BOARD OF ZONING APPEALS STAFF REPORT

Agenda Item: BZA Docket No. 22-010

Summary: BZA 22-010 Community Foundation of Northwest Indiana requesting approval of multiple variances from the Munster zoning ordinance in order to construct an immediate care medical building at 730 Treadway Drive (*formerly 10240 Calumet Avenue*).

Staff Recommendation: Denial

Proposed placement - East Elevation - 3/32" = 1'

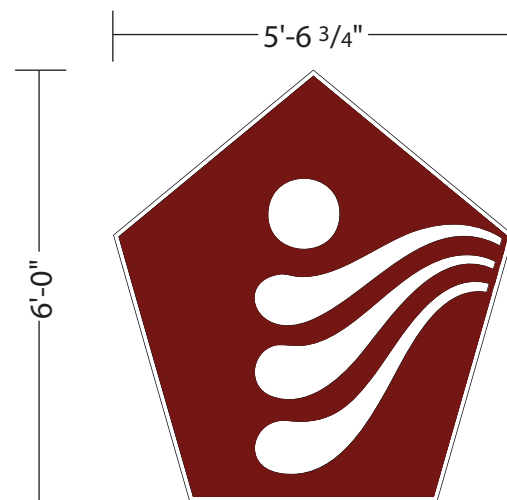
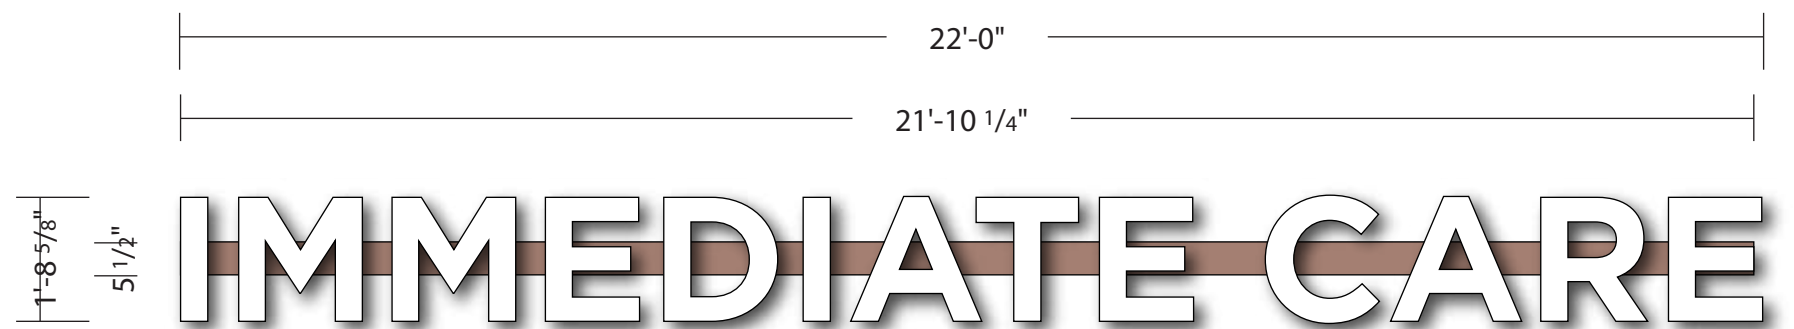
Code Section	Standard	Permitted	Proposed	Number of Variances
Table 26-6.701.B Sign Types – Wall Sign – Specific Standards	Quantity	Maximum 1 per Façade - a single sign on the north side of the building	2 signs on the north side, 2 signs on the south side, and 2 signs on the east side	5
Table 26-6.701.B Sign Types – Wall Sign – Specific Standards	Material	Channel letters, flat cut out acrylic, pvc, metal, wood or like material; or routed etched on wood or like material; or static neon	3 Community Logo signs internally illuminated flex face with translucent vinyl graphics	3
Table 26-6.701.B Sign Types – Wall Sign – Specific Standards	Dimensions – Letter Height	Channel letter(s): max 24” Flat cut out acrylic, pvc, metal, wood or like material; or routed etched on wood or like material; or static neon: max 36”	2 Community Logo signs with height of 72”; 1 Community Logo sign with a height of 48”	3

Table 26-6.701.B Sign Types – Wall Sign – Specific Standards	Dimensions – Overall Height	Channel letter(s): max 36” Flat cut out acrylic, pvc, metal, wood or like material; or routed etched on wood or like material; or static neon: max 48”	2 Community Logo signs with height of 72”; 1 Community Logo sign with a height of 48”	3
Table 26-6.701.B Sign Types – Wall Sign – Specific Standards	Additional Standards	a. Shall be applied to the first Story Façade and not project vertically above the roof line	3 Community Logo signs on second story	3

Table 26-6.701.B Sign Types – Wall Sign – Specific Standards	Additional Standards	d. Vinyl may not be used to create any design	3 Community Logo signs with vinyl creating design	3
---	-------------------------	--	--	---

- Eliminate the 6’-4” tall logo signs installed on the second floor north, east, and west sides of the building.
- Eliminate the “Immediate Care” sign on the east side of the building.
- Reduce the size of the “Immediate Care” sign on the rear of the building to 6 square feet and eliminate the internal illumination.
- Reduce the size of the monument sign to 18 square feet and reduce the height of all letters and logos to 12”.
- Redesign the monument sign with solid materials rather than a cabinet.

DRAWING: SO-0340-4B

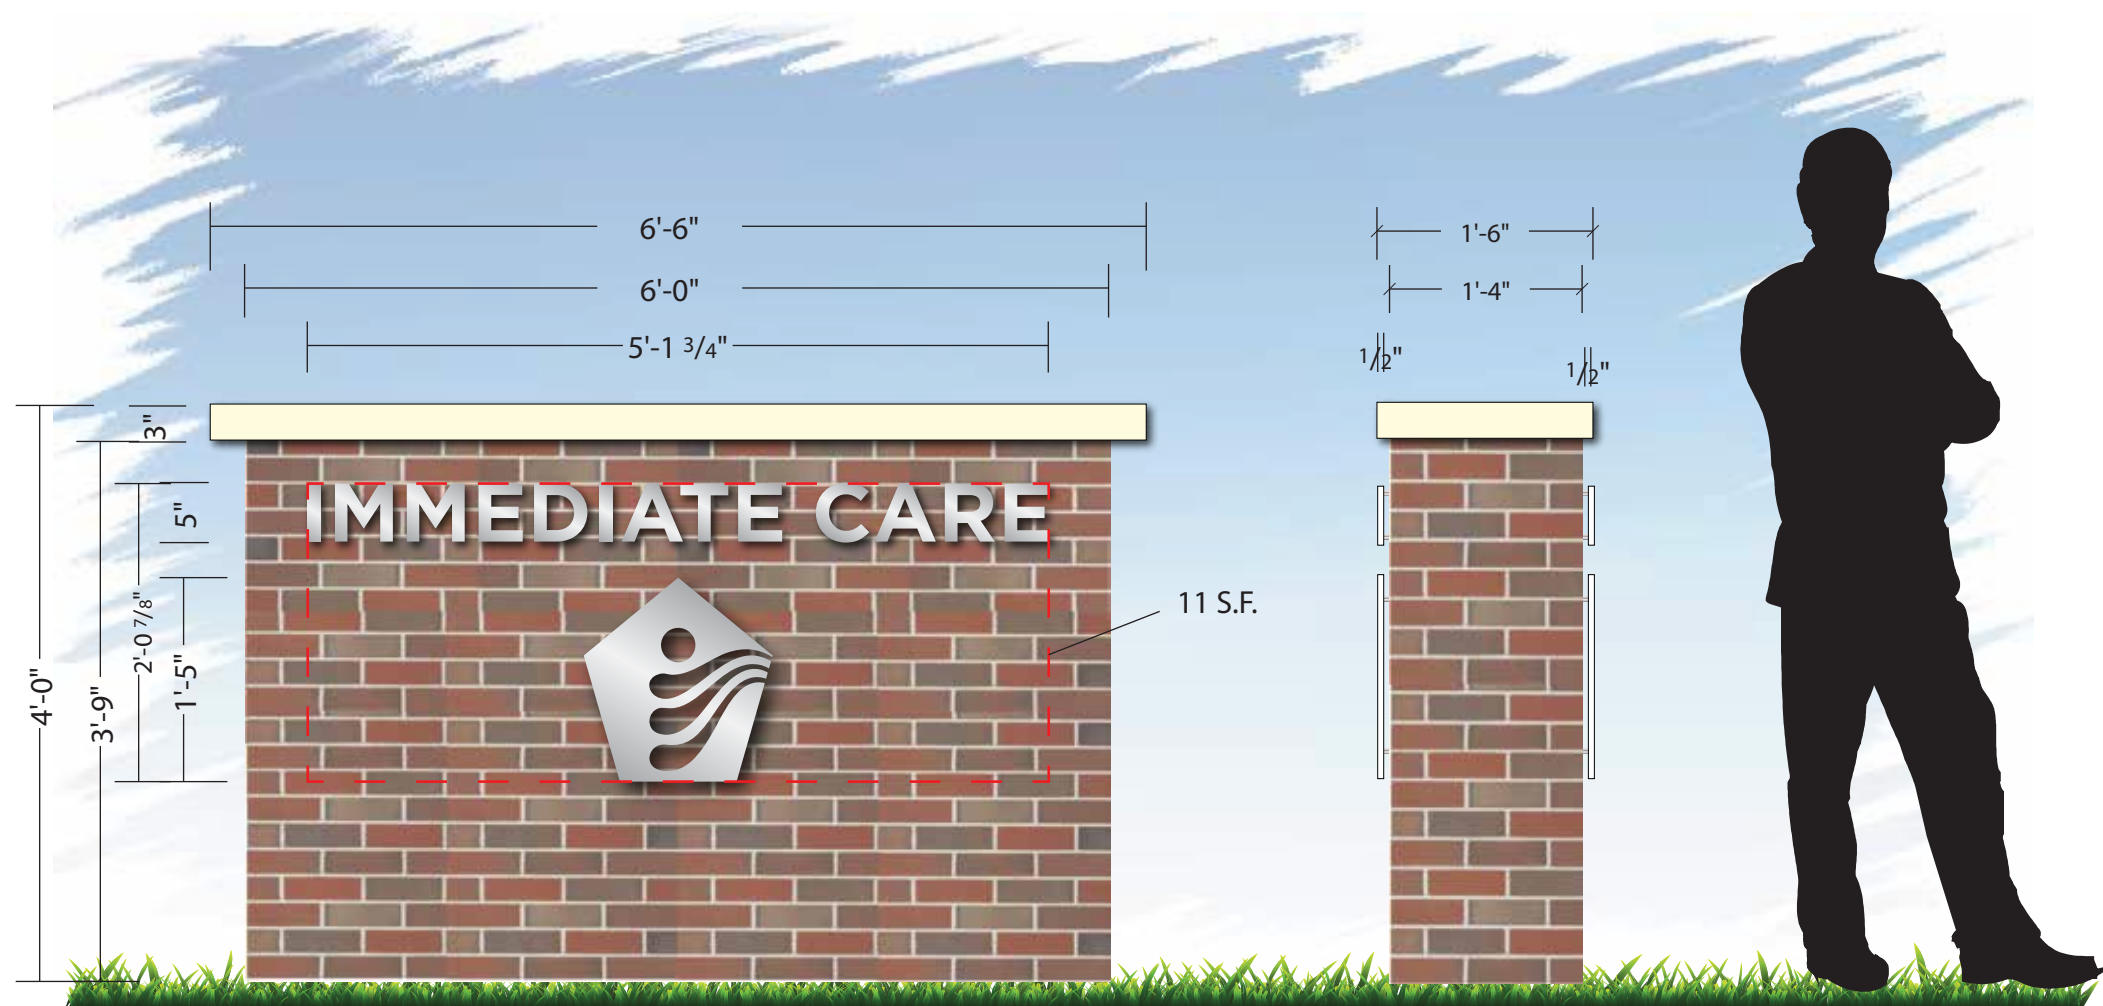
Code Section	Standard	Permitted	Proposed	Number of Variances
Table 26-6.701.B Sign Types – Monument Sign – Specific Standards	Dimensions – Letter Height	Maximum 12 inches	Community Logo height 17 inches	1
